Report to the Northern Regional Planning Panel on an application for a site compatibility certificate – State Environmental Planning Policy (Housing for Seniors or People with a Disability) 2004

SITE: The site compatibility certificate (SCC) application applies to part of Lot 10 DP 1088869, John Oxley Drive, Port Macquarie. The proposed development is to be located only on the part of the lot south of the Oxley Highway (Figure 1). The southern portion of the site is vacant except for a 1.2ha area being used by the adjoining landscape supplies business for storage.

APPLICANT: Land Dynamics Australia

Figure 6: Port Macquarie-Hastings UGMS 2017-2036.

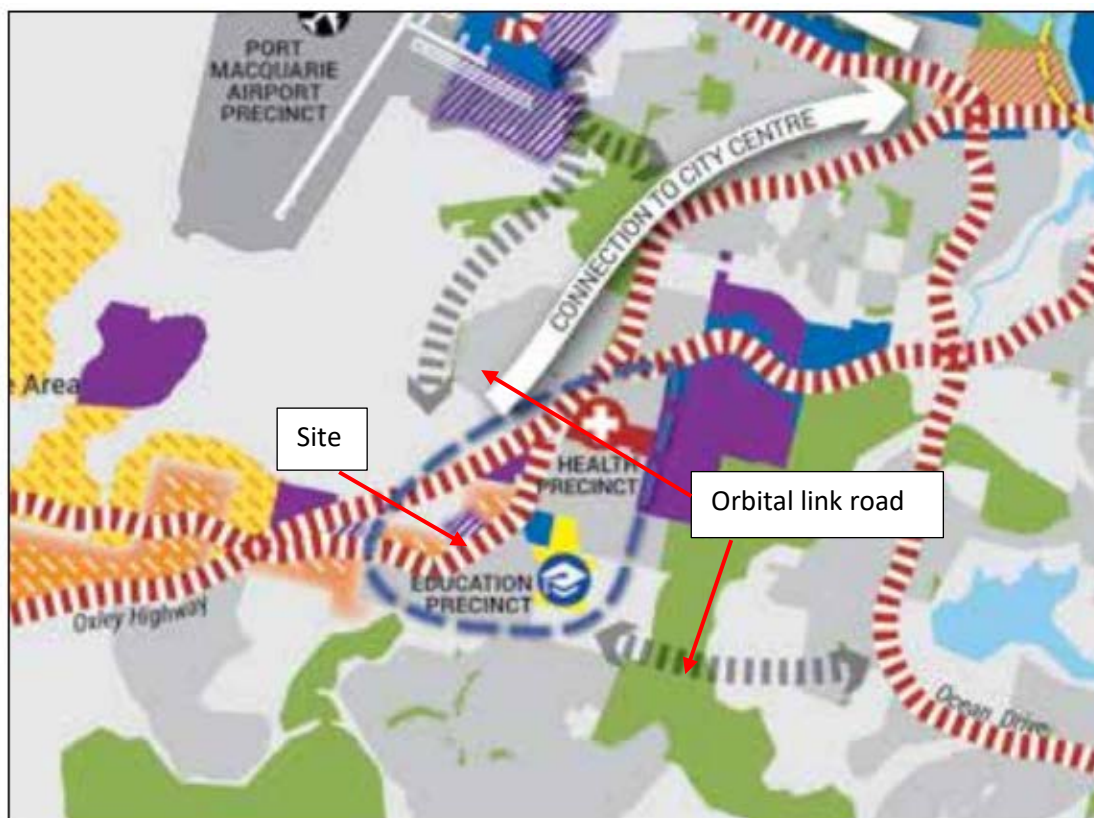
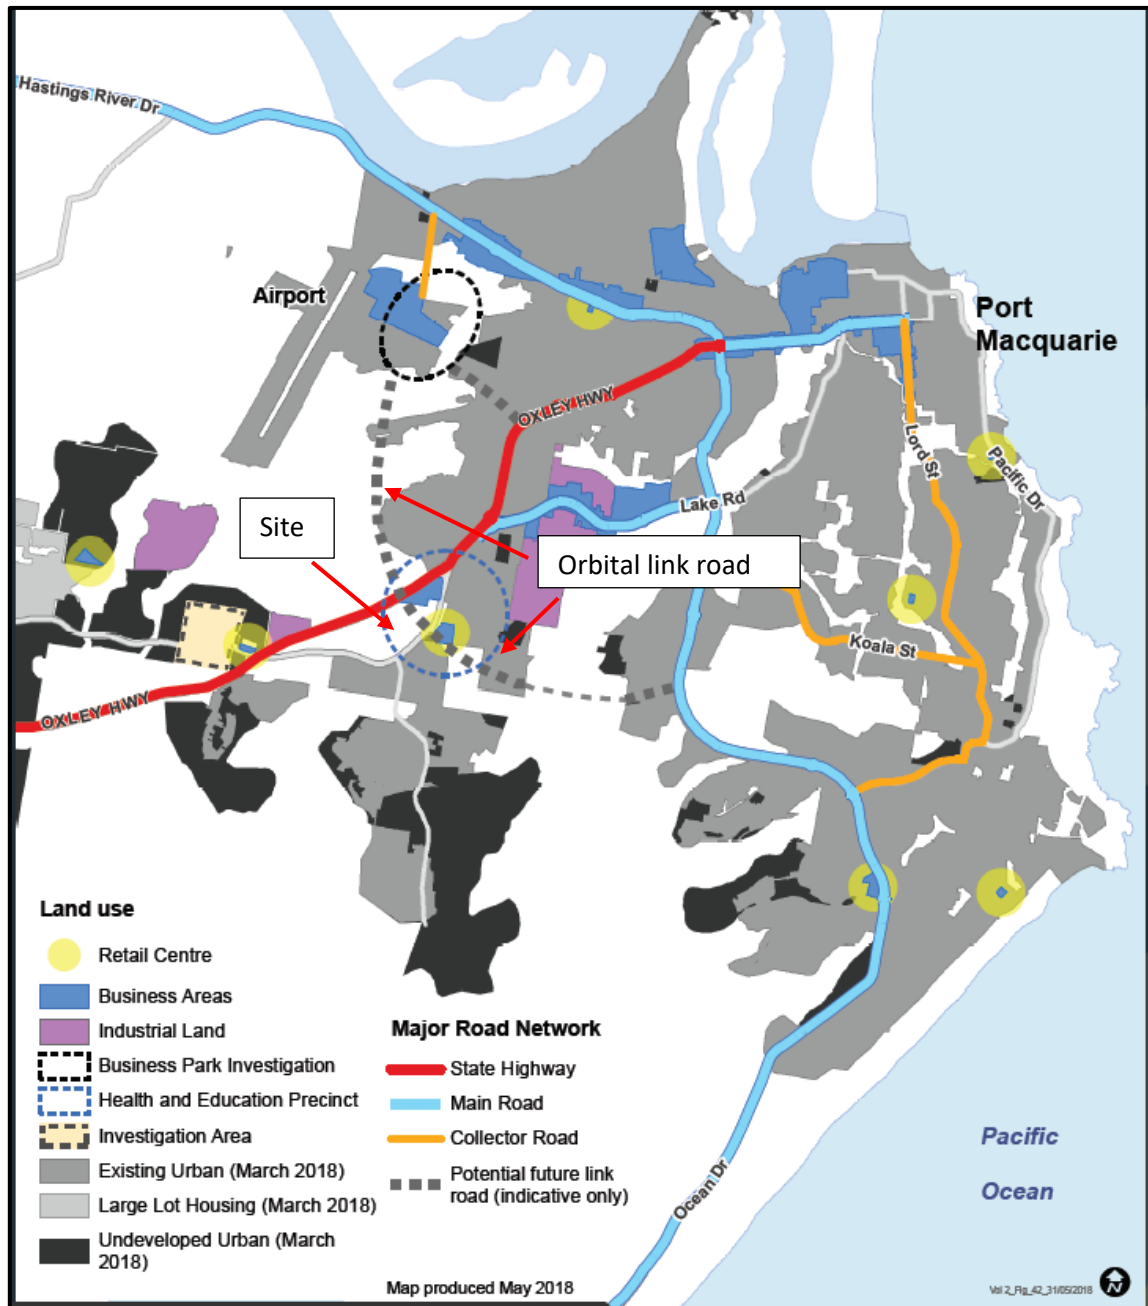
- the Coastal Management SEPP wetland and proximity area;
- coastal floodplain endangered ecological communities;
- flooding;
- bushfire-prone land;
- noise from the adjoining Oxley Highway;
- water and sewer system capacity;
- potential contamination; and
- identification in the North Coast Regional Plan 2036 and Council's Department-approved Urban Growth Management Strategy (UGMS) 2017-2036 as being bisected by a potential orbital link road between Port Macquarie Airport and Ocean Drive (Figures 5 and 6).

The highly constrained nature of the site was identified in Council's John Oxley Drive Precinct Structure Plan endorsed by the Department in November 2012 (as an amendment to Council's former UGMS 2011). That plan noted the site had major flooding and environmental conservation constraints. For this reason, no development was identified in the structure plan and it was noted that should owners wish to develop, they would need to prepare detailed planning proposals that demonstrate satisfactory outcomes in relation to the land constraints.

As discussed further in this report, it is considered that the current SCC application does not provide sufficient detail or evidence to confirm that the site is suitable for the proposed development regarding flooding, potential contamination, infrastructure, building height or the proposed orbital link road. While some constraints could be satisfactorily addressed through appropriate design responses at the development application stage should an SCC be issued, it is considered that any development of the site for more intensive purposes would be premature until Council finalises the masterplan for the area. It is understood that the masterplan will

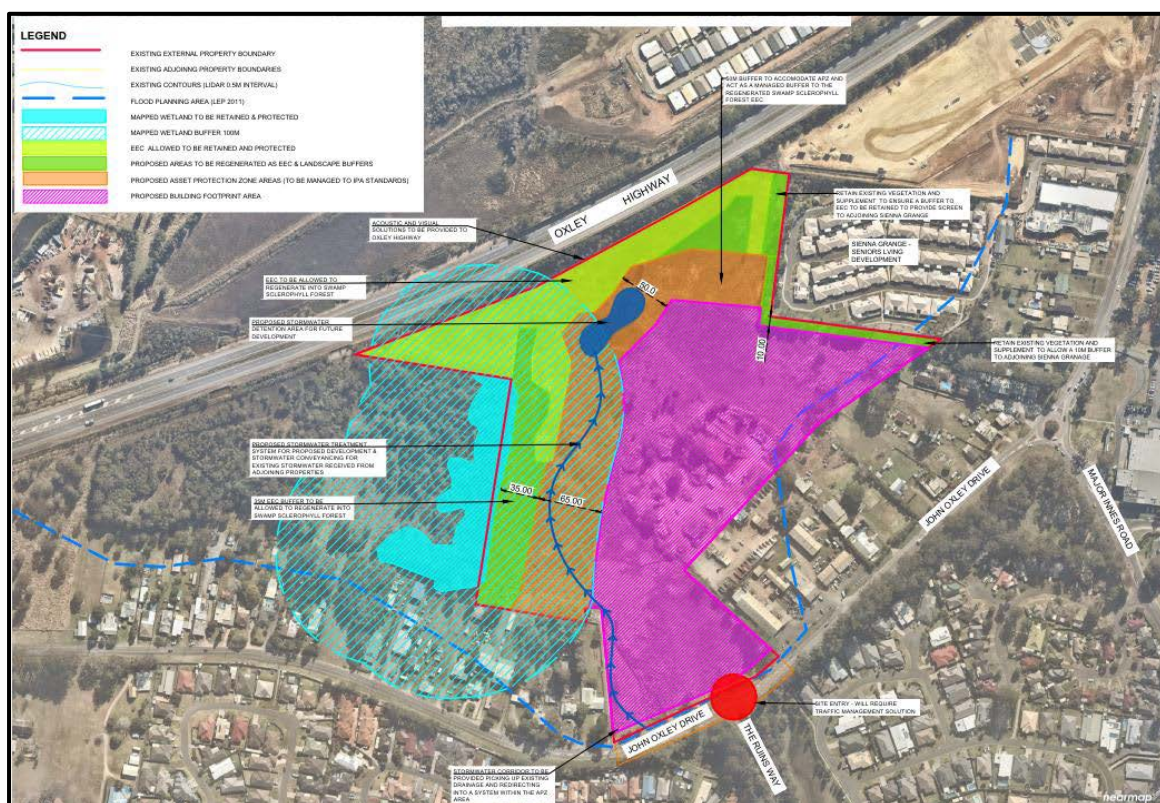
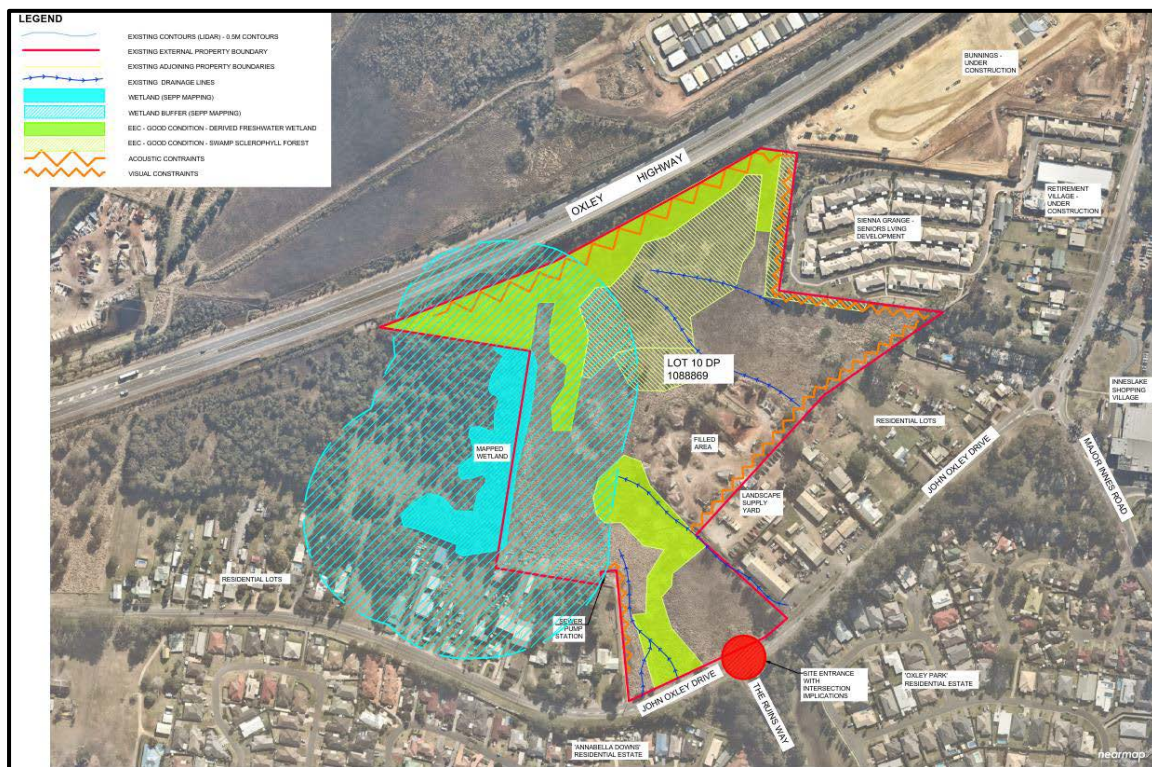
Despite its modified state, much of the site qualifies as containing coastal floodplain endangered ecological communities (EEC) under the *Biodiversity Conservation Act 2016* (shown in green and green hatch in Figure 7). The western boundary of the subject area is mapped as coastal wetlands and proximity area for coastal wetlands under the Coastal Management SEPP (shown in blue and blue hatch in Figure 7).

The proposal shows that the development footprint will impact significantly on areas of the identified EEC (Figures 3, 7 and 8) by bushfire asset protection zones, recreational and community uses, accommodation buildings, internal roadways and stormwater uses. To offset any potential adverse environmental impacts, the proposal seeks to regenerate on-site approximately 2.9ha of EEC (shown in green and light green in Figure 8).

As discussed previously, the Department's position is that an SCC cannot be issued for the area identified as proximity to the Coastal Management SEPP wetland in accordance with clause 4(6) and schedule 1 of the Seniors Housing SEPP. Should the panel determine to support the issuing of an SCC for the site, it is recommended that it include a requirement to clarify that the footprint of the development and any associated works must be located outside the coastal wetland proximity area.

Figure 9: Bushfire-prone land.

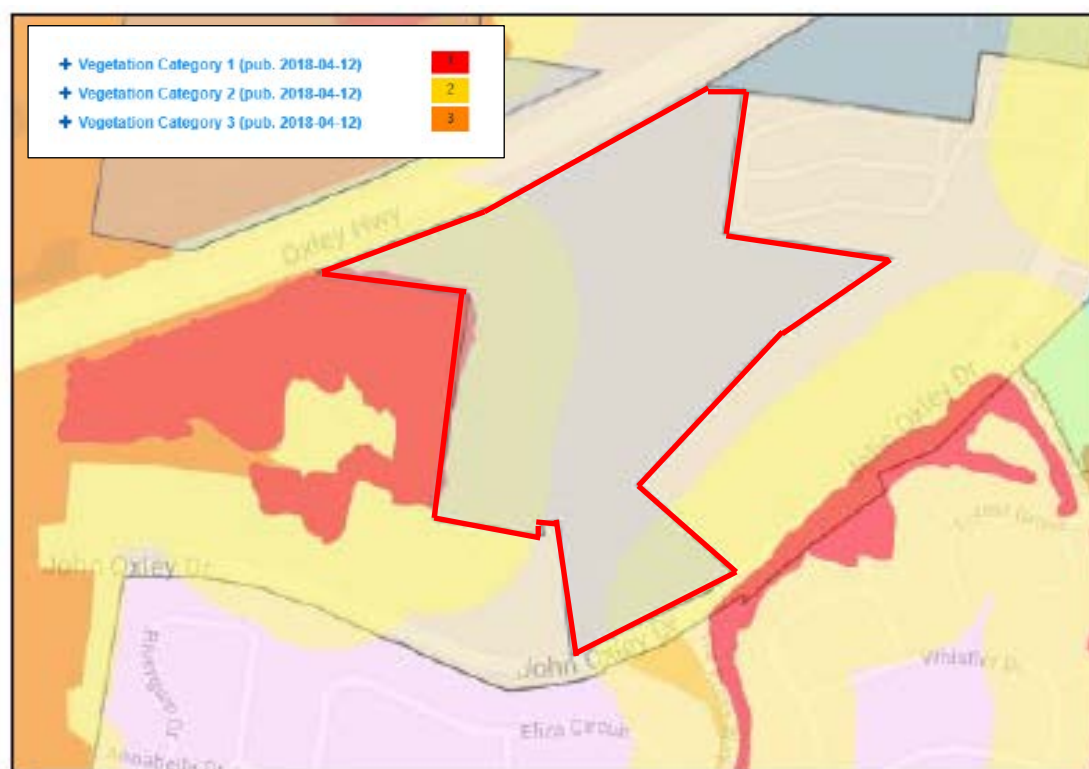
Only a small part of the site is mapped as bushfire-prone land (Figure 9). A bushfire assessment has been conducted by the proponent for the site and concludes that the bushfire risk is manageable.

As discussed above, bushfire asset protection zones have been identified as being located within the mapped proximity to coastal wetland area. Should the proposal proceed, any asset protection zones would need to be relocated outside the proximity area and would likely require the size and scale of the proposal to be reduced. As the proposal is a special fire protection purpose under the *Rural Fires Act 1997* and consultation and approval from the NSW Rural Fire Service will be required before a development can proceed, it is considered that this matter can be adequately addressed at the development application stage should an SCC be issued.

Figure 12: Location of services.

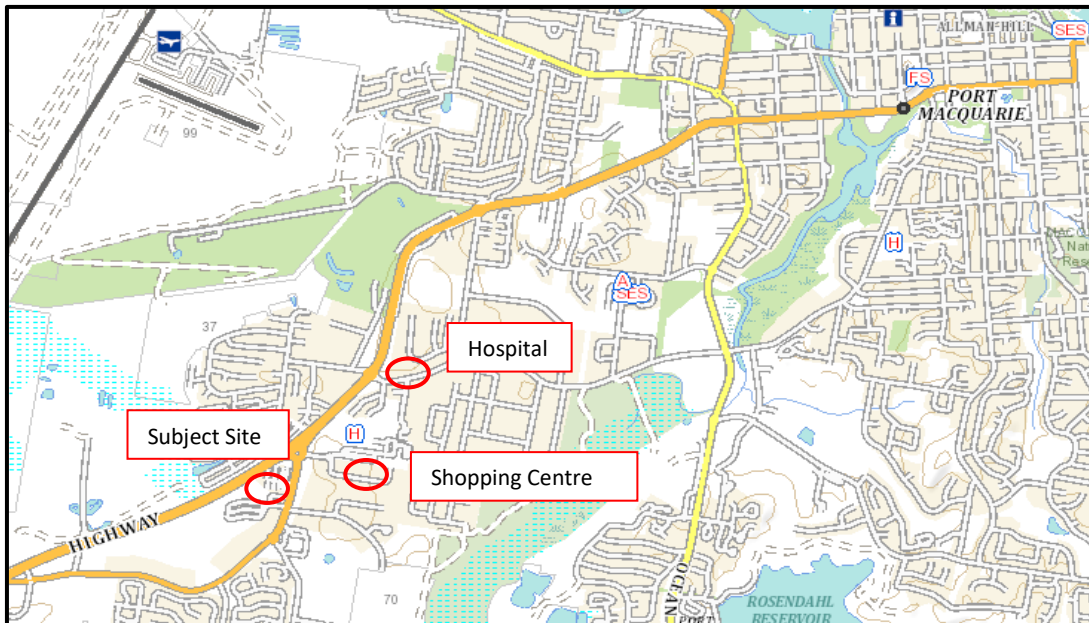
Approximately 400m from the subject site is the Lake Innes neighbourhood shopping centre, which includes a supermarket and specialty shops including a doctor, a dentist, a café, a bakery, a butcher, takeaway food premises and a travel agent (Figure 12). Regular bus services are available from two bus stops on John Oxley Drive, connecting to the Port Macquarie CBD (with buses running approximately every 30-60 minutes in the morning and every 60 minutes in the afternoon), which has a wide range of retail, community and medical services (Figure 13). As these bus stops are further than 400m from the site, the proponent has advised that a private bus service for residents will be incorporated into the development. This meets the requirements of clause 26(2)(c) of the Seniors Housing SEPP.

It is understood that the gradient of the access route to the neighbourhood shopping centre also meets the requirements of clause 26(2)(c) of the Seniors Housing SEPP. However, a suitable access pathway would need to be formed.
